November 7, 1984

The Commission has issued the enclosed Amendment No. 87 to Facility Operating License No. DPR-23 for the H. B. Robinson Steam Electric Plant Unit No. 2. This amendment consists of changes to the Technical Specifications in response to your request dated July 23 and August 1, 1984, as supplemented by letters dated August 8, 17, 20(2), and 23, 1984; September 7(2) and 17, 1984; and October 4, 12, and 22, 1984.

SAFETY EVALUATION BY THE OFFICE OF NUCLEAR REACTOR REGULATION  
RELATED TO AMENDMENT NO. 87 TO FACILITY OPERATING LICENSE NO. DPR-23  
CAROLINA POWER AND LIGHT COMPANY  
H. B. ROBINSON STEAM ELECTRIC PLANT, UNIT NO. 2  
DOCKET NO. 50-261

**CORE PROTECTION BOUNDARIES FOR 3-LOOP OPERATION**  
 Figure 2.1-1

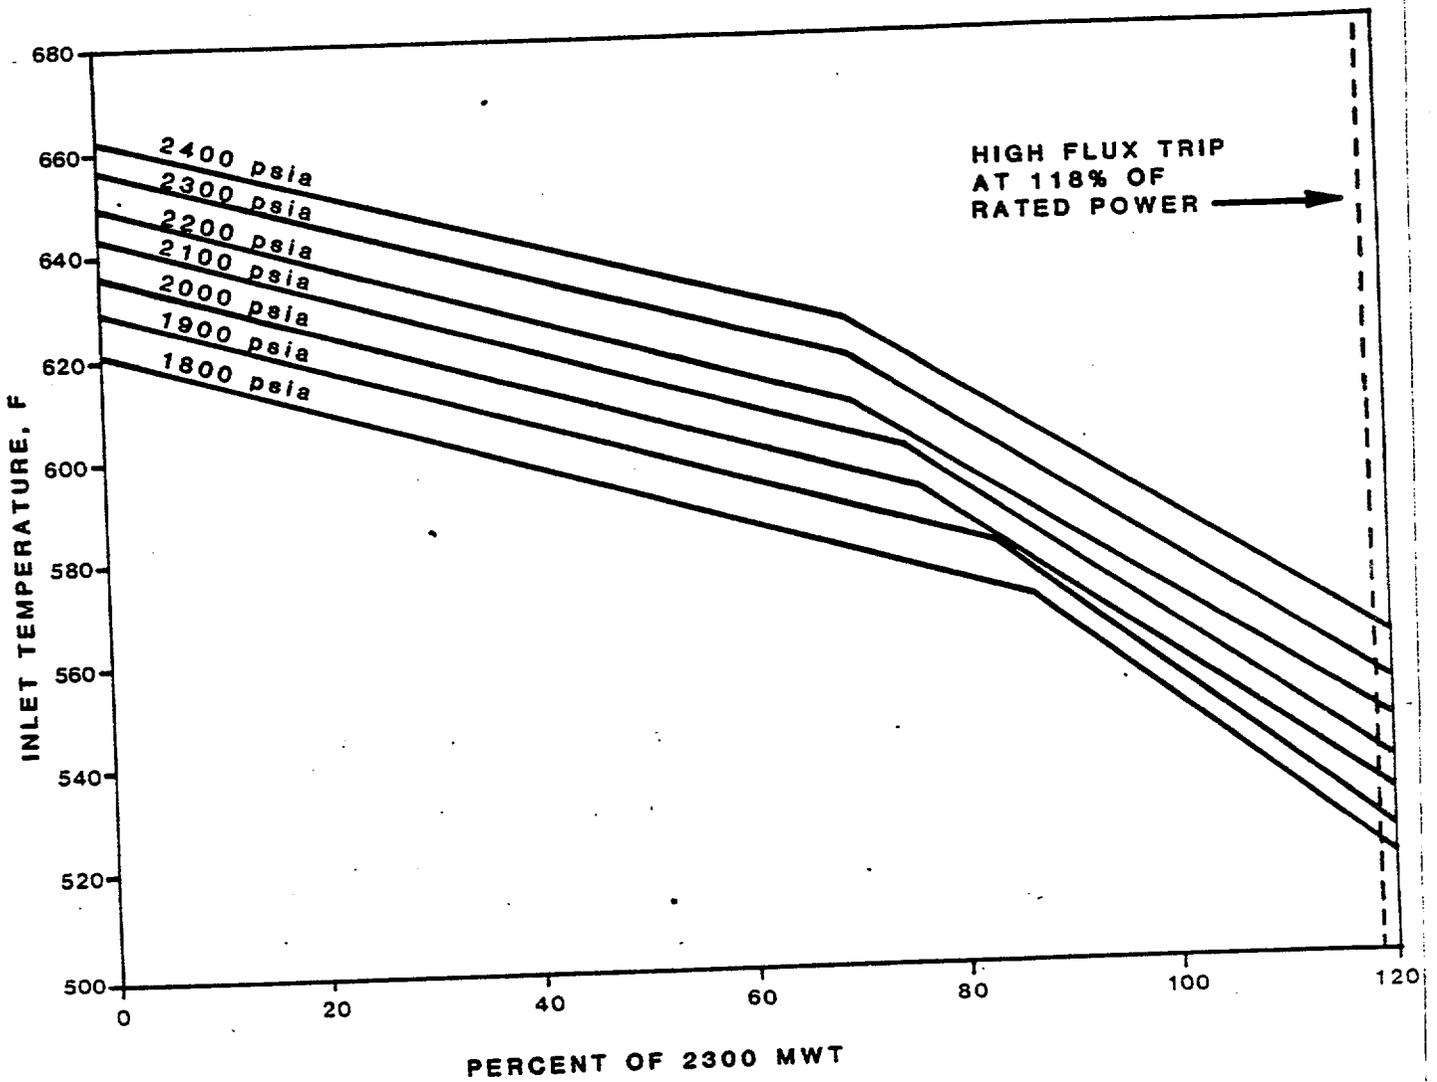
#### Technical Specification 2.1, Figure 2.1-1

This figure shows the limits and the allowable combinations of thermal power, coolant pressure and coolant inlet temperature, under full flow conditions. The Technical Specification limits shown incorporate the new DNB correlation, the new thermal power level of 2,300 Mwt the new hot channel factors and the combined steady state uncertainties. The changes indicated in Technical Specifications 2.1 (a) and 2.1 (d) and in the basis of 2.1 (TS 2.1 pp 1-5, attachment 8. Ref. 1 and the editorial changes of reference 18) have been reviewed and found to be in agreement with approved changes and, therefore, are acceptable.

Figure 3.10-3

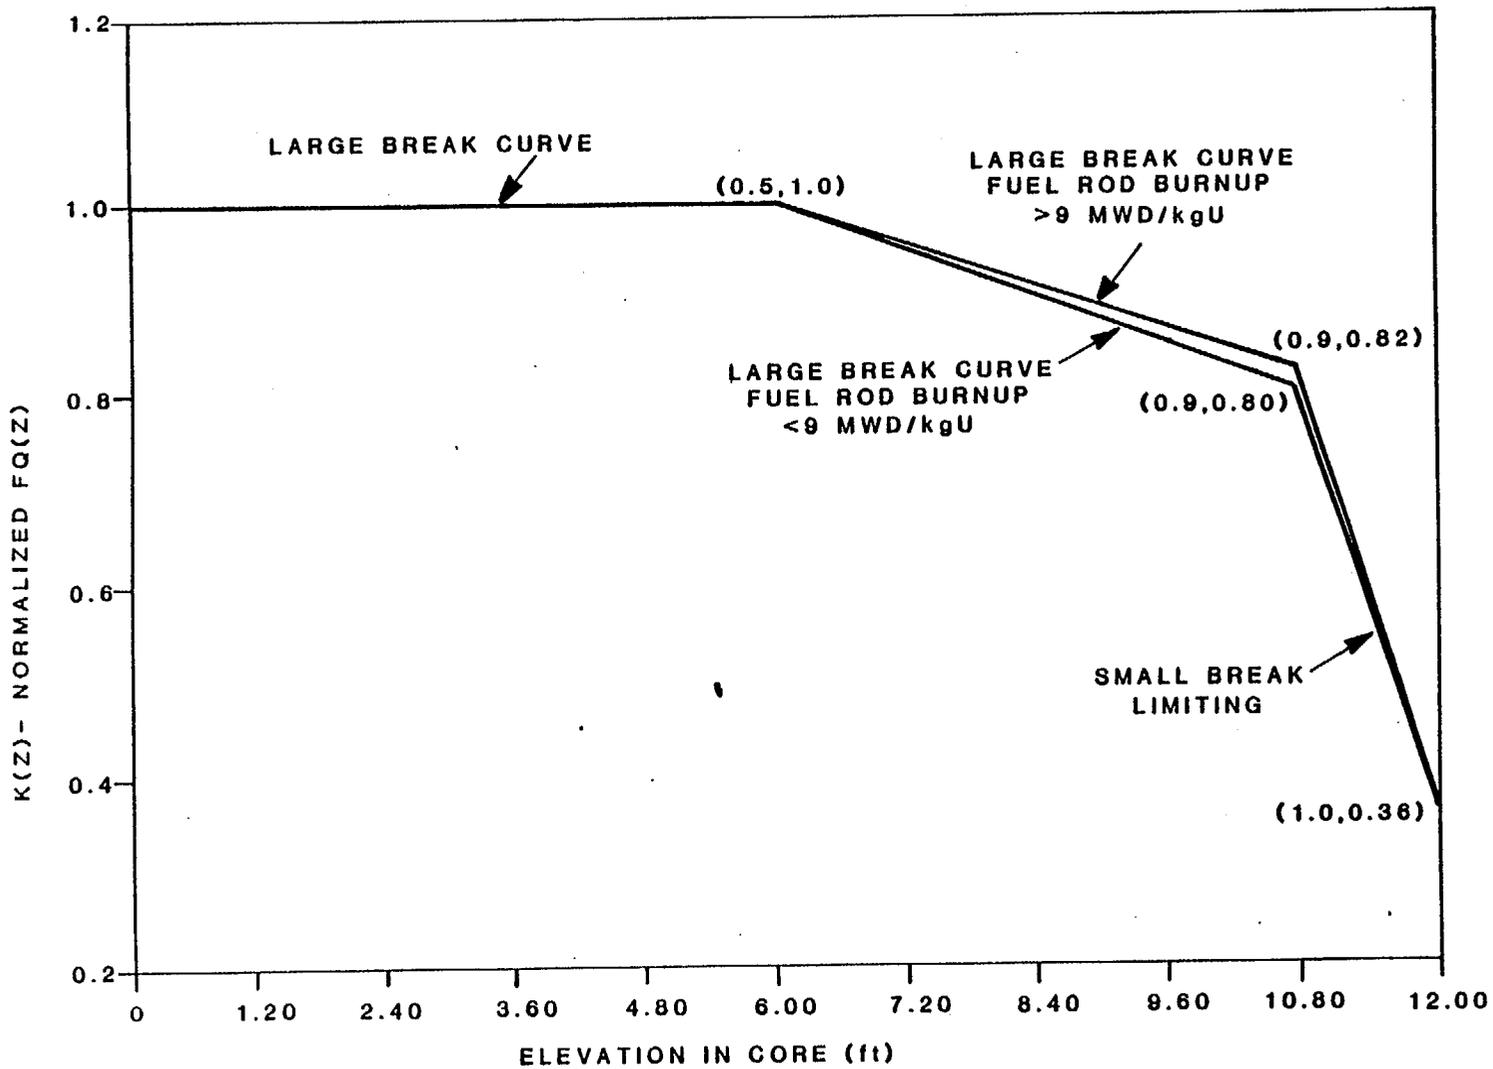
3. September 7, 1984 (84-400) resubmitted a  $K(z)$  curve for the Technical Specifications. Confirmatory analysis, since the original (July 23, 1984) submittal, necessitated minor revisions to the curve. This was a minor revision to an already submitted document resulting from a standard analytical process, therefore, it was not a significant change or a new submittal.

To define allowable linear heat generation rates as a function of core elevation, HBR-2 utilizes the K(z) curve. This curve, which is given in Figure 3.10-3 of the HBR-2 Technical Specifications, defines the normalized peaking factor, relative to the total peaking factor,  $F_Q^T$  of 2.32, as a function of elevation. To confirm that the linear heat generation rates allowed by the K(z) curve satisfies the requirements of 10 CFR 50.46, the licensee submitted additional LOCA analyses in reference 3.

Time (s)  
H.B.ROBINSON CYCLE 10 RELOAD  
STEAM LINE BREAK ANALYSIS  
BREAK DOWNSTREAM OF FLOW RESTRICTORS  
FIGURE A-8

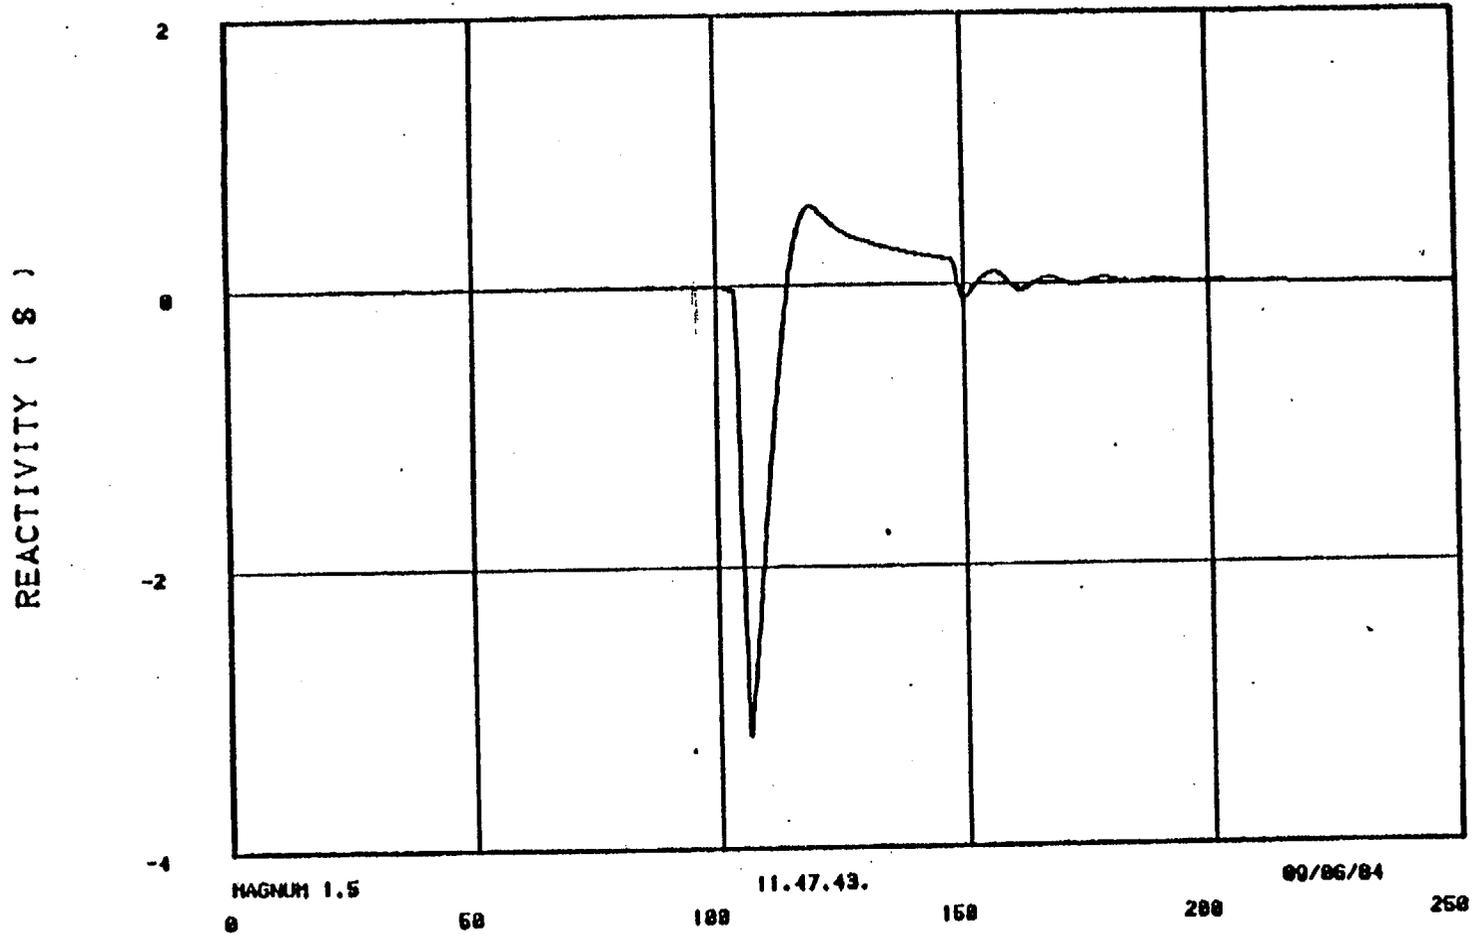
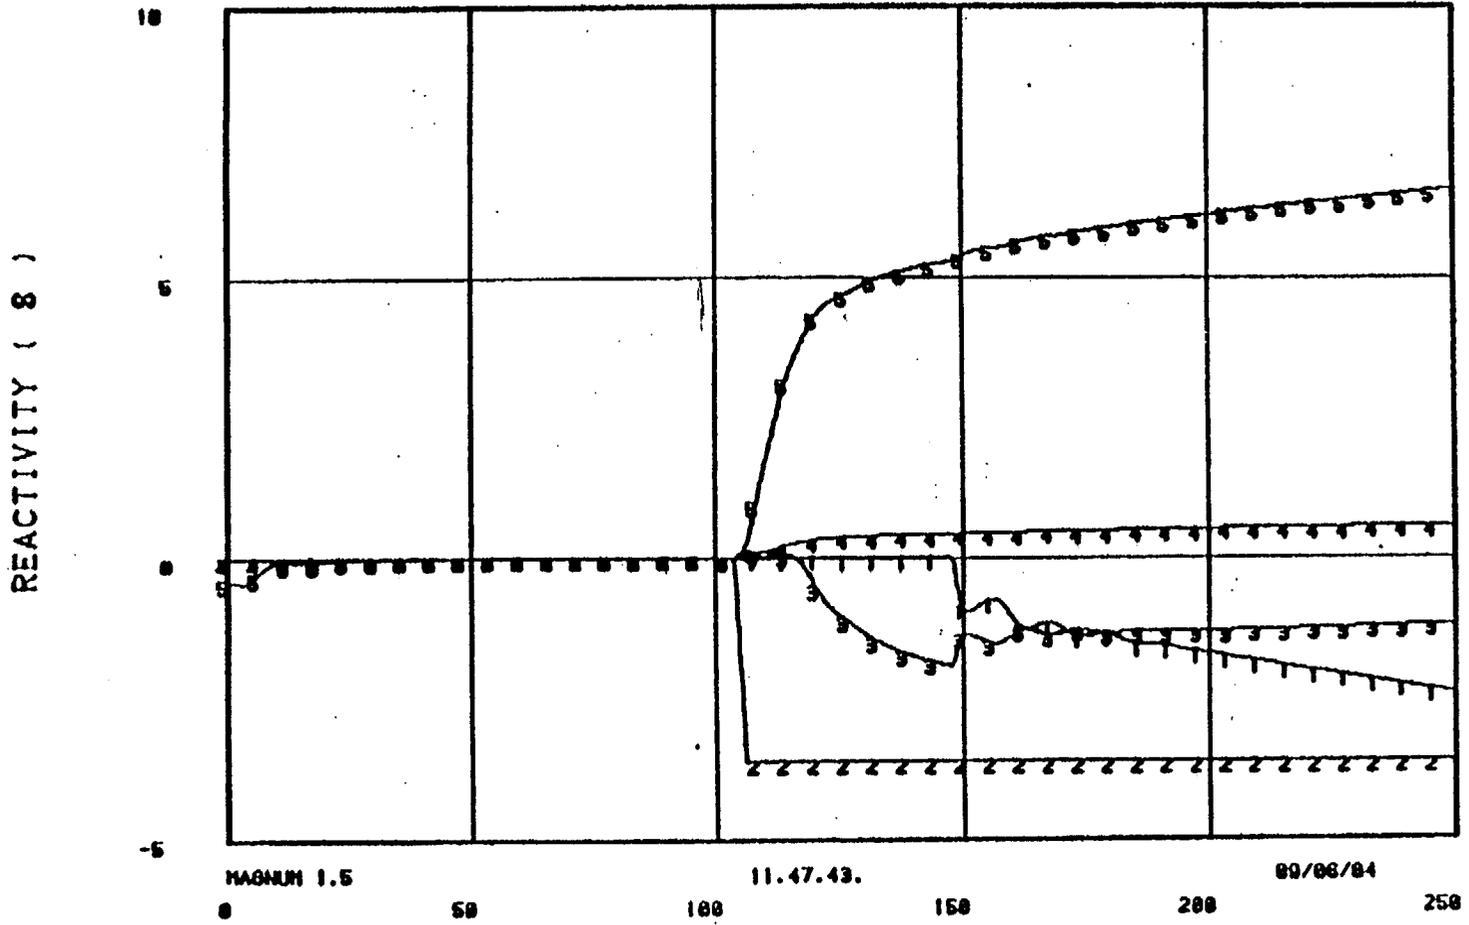
The reactivity for the limiting case is shown in Figure A-8 and A-9. The initial reactivity begins at zero. \$3.61 of negative reactivity is inserted by the control rods between 0.2 and 2.4 seconds. As the primary system is cooled, positive reactivity is inserted by the moderator and Doppler feedbacks. Criticality occurs at 14.6 seconds. At 19 seconds the reactivity peaked at \$0.58. At 46.6 seconds, boron enters the core through the emergency core cooling system (ECCS).

Time (s)  
H.B.ROBINSON CYCLE 10 RELOAD  
STEAM LINE BREAK ANALYSIS  
BREAK DOWNSTREAM OF FLOW RESTRICTORS  
FIGURE A-10

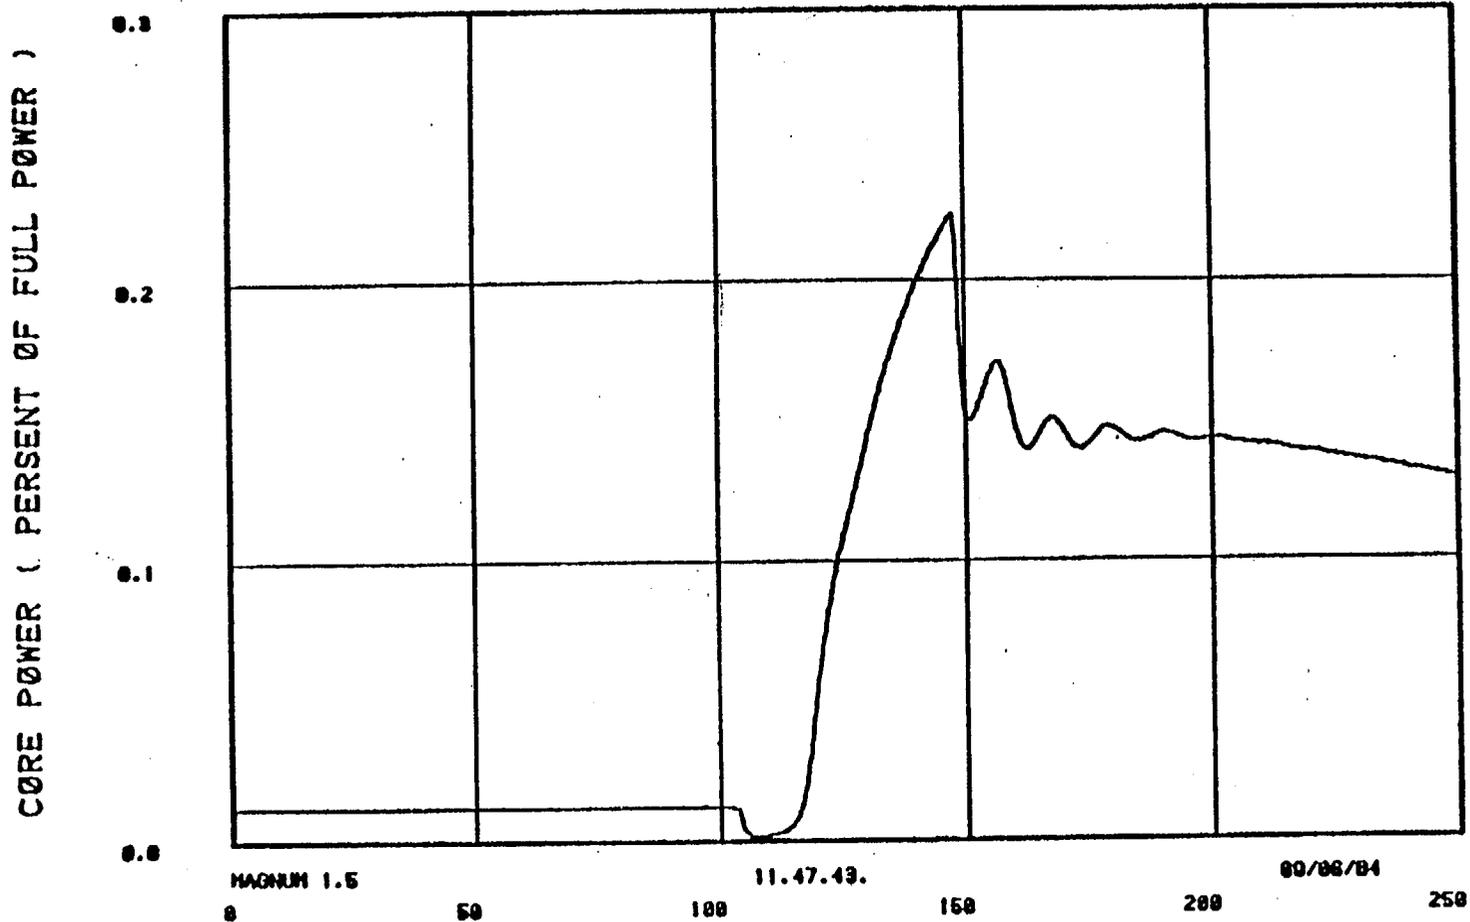
The reactor power response is shown in Figure A-10. The power peaked at a value of 22.4% of rated power (2300 Mwt) at 47 seconds. Competing effects between the boron and Doppler reactivities led to some oscillatory power response.

Time (s)  
H.B.ROBINSON CYCLE 10 RELOAD  
STEAM LINE BREAK ANALYSIS  
BREAK DOWNSTREAM OF FLOW RESTRICTORS  
FIGURE A-11

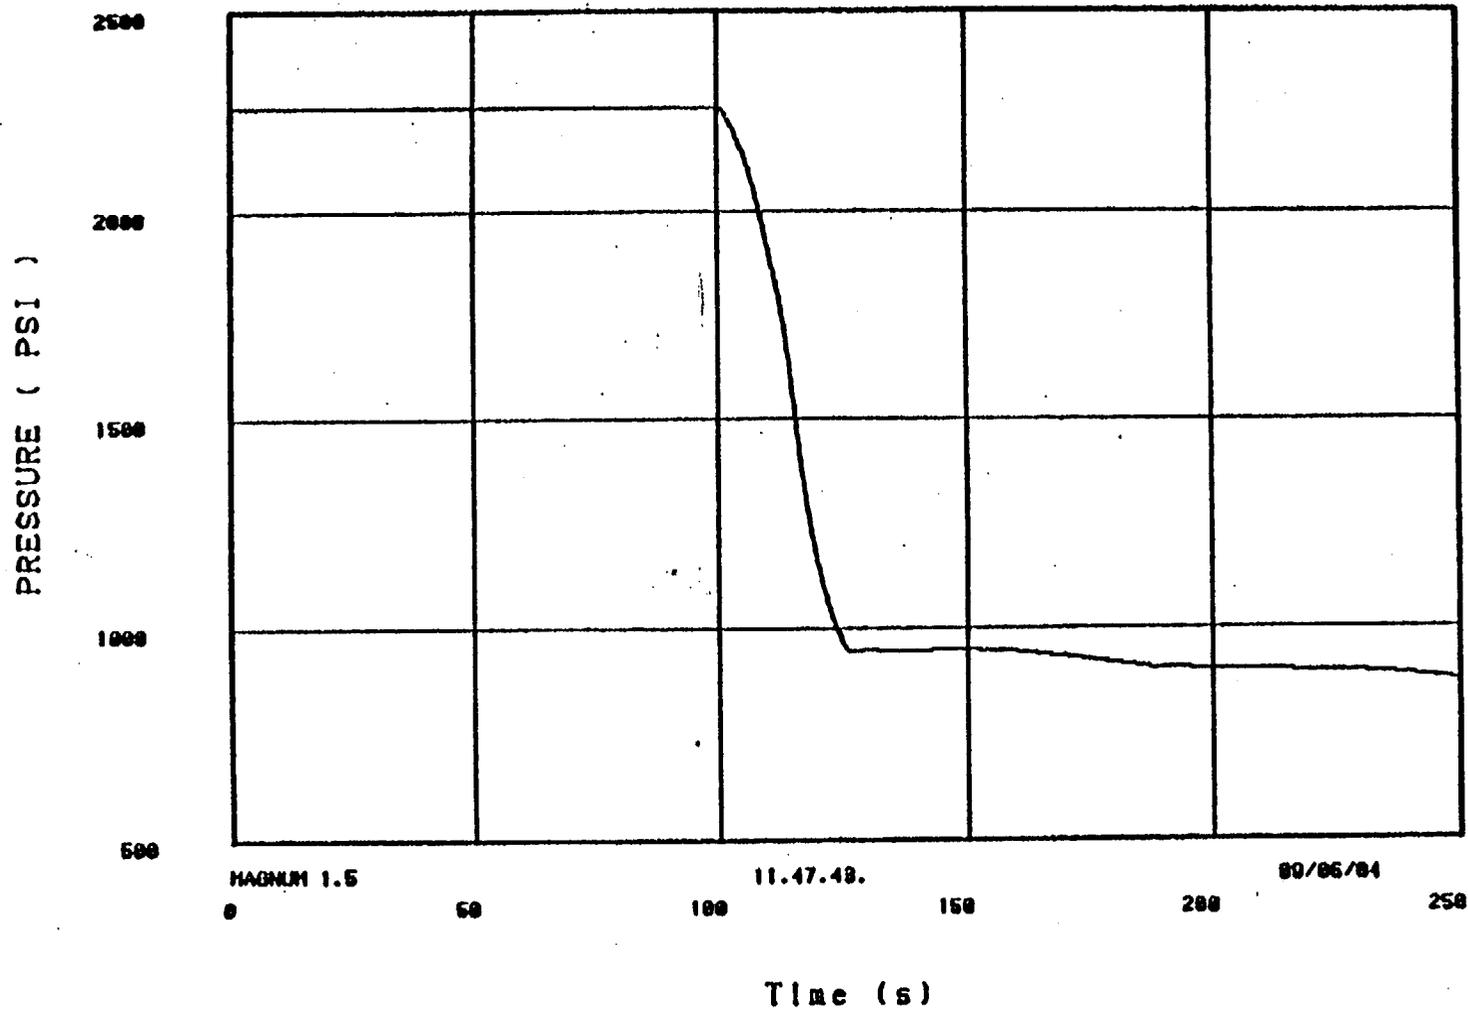
Heat removal from the primary system led to a rapid decrease in primary system pressure (see Figure A-11). The depressurization rate is significantly reduced as the reactor vessel voids within the upper head. The pressurizer is depleted of liquid inventory at the same time as the depressurization rate decreased (see Figure A-12).

Time (s)  
 H.B.ROBINSON CYCLE 10 RELOAD  
 STEAM LINE BREAK ANALYSIS  
 BREAK DOWNSTREAM OF FLOW RESTRICTORS  
 FIGURE A-13

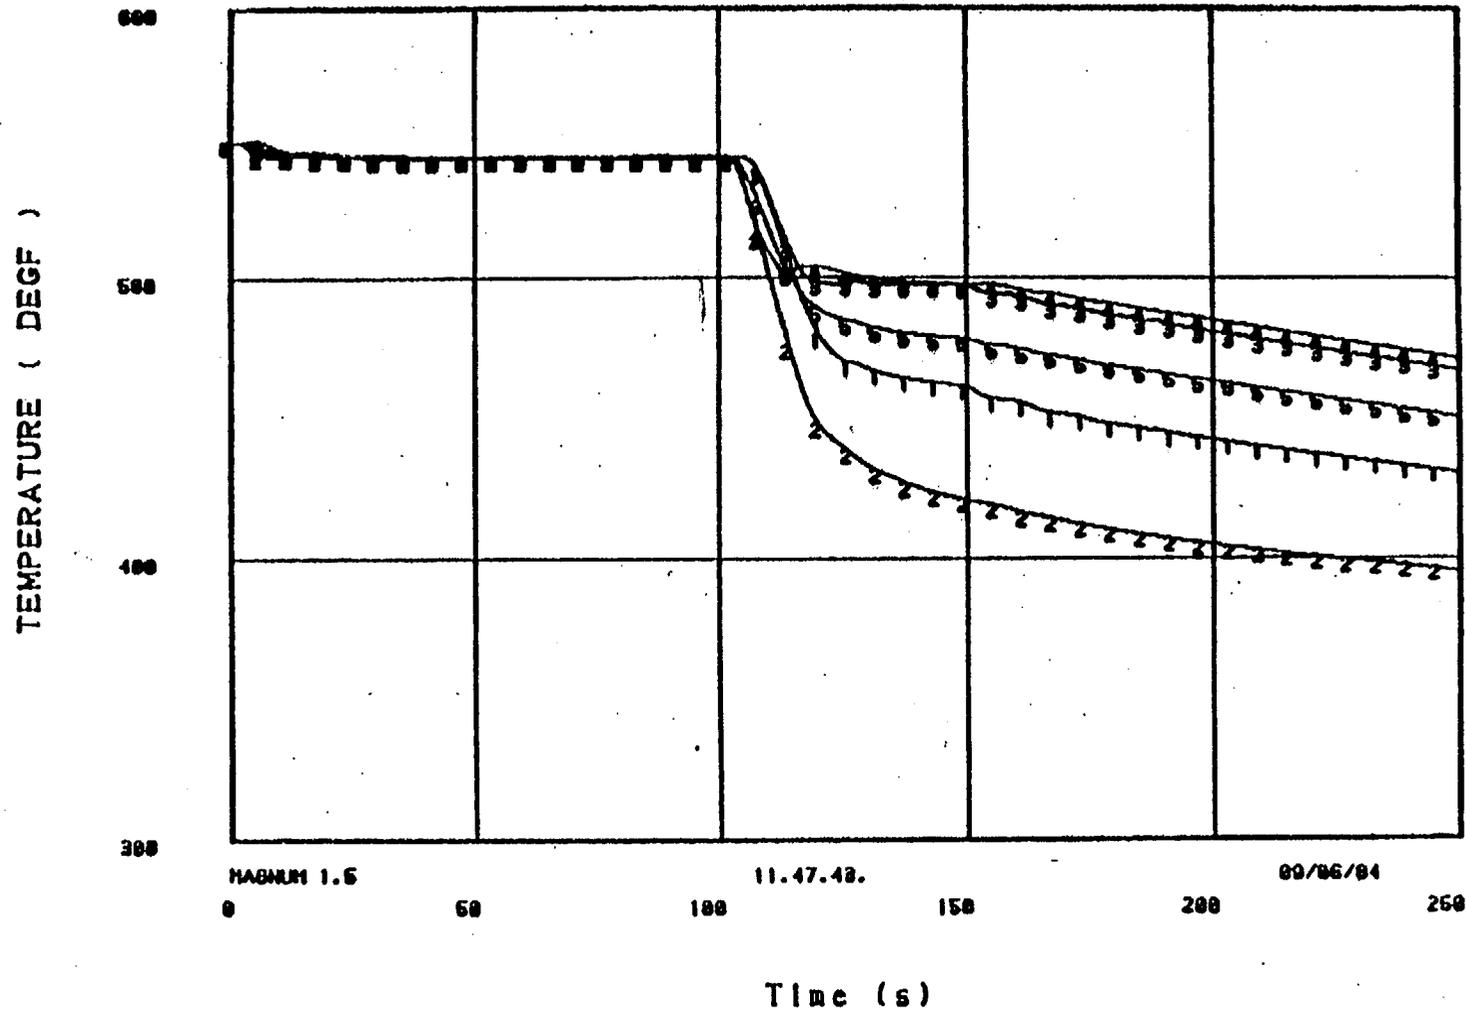
The hot leg and cold leg coolant temperature for both the affected and intact loops, along with the average core coolant temperature, are shown in Figure A-13. As noted by the decreasing coolant temperatures, the energy removed by the steam generators exceed
